SIB 61 06 15

Washer Fluid Reservoir Rattles While Driving on Rough Roads

This Service Information Bulletin (Revision 4) replaces SI B61 06 15 **dated April 2021**.

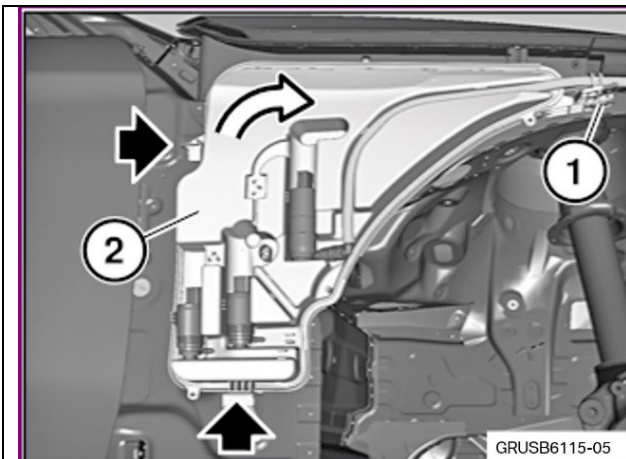
The windshield washer reservoir upper plastic locating guide tab has too much lateral play.

Apply a piece of self-adhesive felt tape to the upper plastic locating guide of the washer fluid reservoir.

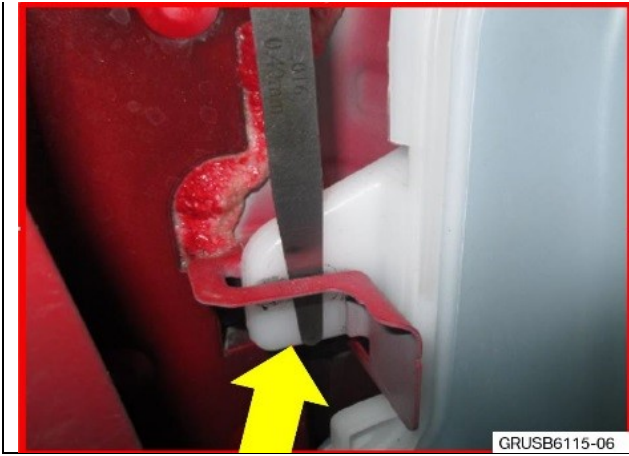
- Note: The close-up picture shows a gap (0.40 mm) that exists between the plastic reservoir guide and the metal securing bracket.**
6. With the reservoir removed, clean the upper guide tab with a clean cloth.

7. Prepare a piece of felt tape (80 x 60 x 1 mm) and apply it to the guide tab in the area shown.
8. The felt tape will eliminate the rattling noises coming from the metal bracket which can transmit into the glove compartment area. Reinstall the removed parts in the reverse order of their removal.
